Safety Recall: 22V270  
April 2022

## IMPORTANT SAFETY RECALL

# \*\*\*Product Safety Notice\*\*\*

## LP QUICK DISCONNECT REPLACEMENT AND TESTING PROCEDURED

LP Quick Disconnect

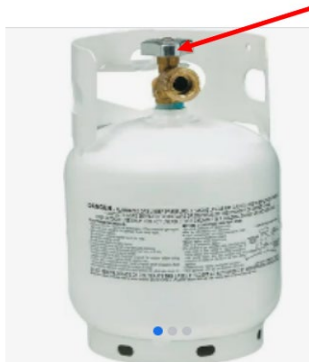
**STEP 1:** Locate the LP Quick Disconnect on the door side (passenger side) of your RV, near the front.

LP Quick Disconnect located near the front of the RV forward of the entrance door down on the chassis rail.

You will find our LP Quick Connect threaded in here.

**STEP 3.** Remove the LP Quick Disconnect and replace with new LP Quick Disconnect.

This replacement must be done with a listed / approved LP Thread Tape or Pipe Dope.

**STEP 4.** Perform the required LP Drop Pressure at 8 inch wc for 3 minutes.

Replacement will require you to order the following p/n's: 12956 = 1/4" to 3/8" Brass Nipple, 21212 = 1/4" to 1/4" Brass Nipple and 12957 = LP Quick Disconnect.
